Product Change Notification

Date Issued :	April 19, 2023	PCN Number :	513522
Reason for Change :	Equipment Transfer, Production Transfer or Rearrangement		
Description of Change :	This notification is to inform you about an equipment transfer that has been issued to manufacture impacted part(s). Equipment has been moved to different site/ location/ premises. No changes will be made to product as part of this change. The additional parts on this PCN are to add to the previously communicated PCN # 512047.		
Reason for Short Notice :	Update Previously Issued Change Notice		
Assessment of Change :	No change to parts - Form/Fit/Function Reliability Test Report/s		
Planned Implementation Date :	May 19, 2023		
Sample Availability Date:	March 31, 2023		
Internal Molex Qualification Date :	March 31, 2023		
Last date to request Samples by Customer :	May 19, 2023		
Traceability Code Markings / Date :	Date code

Guadalajara 2

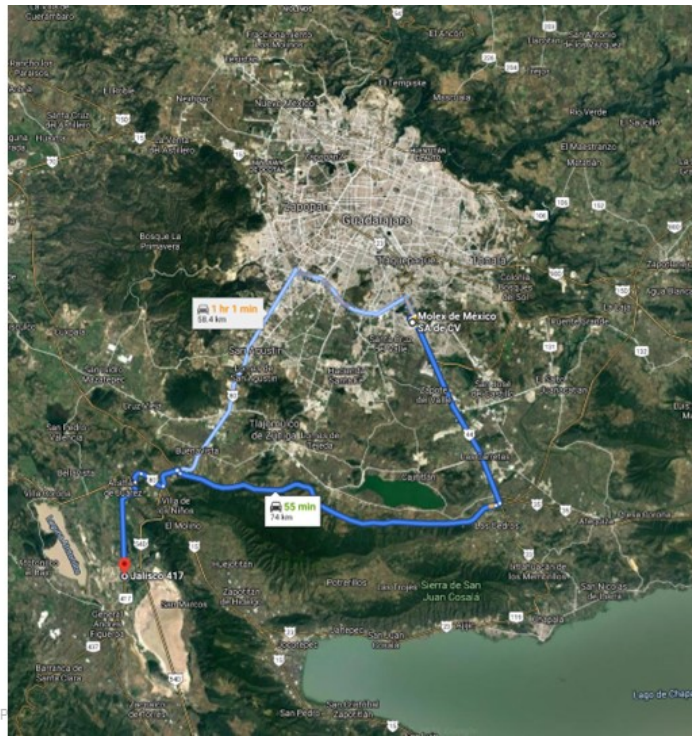
- Located in Centro Logistico Jalisco Industrial Park
- 1 hour from existing Quad1
- Initial build will contain Molding, Assembly, and Reliability Testing capabilities
- A new Distribution Center services Quad2
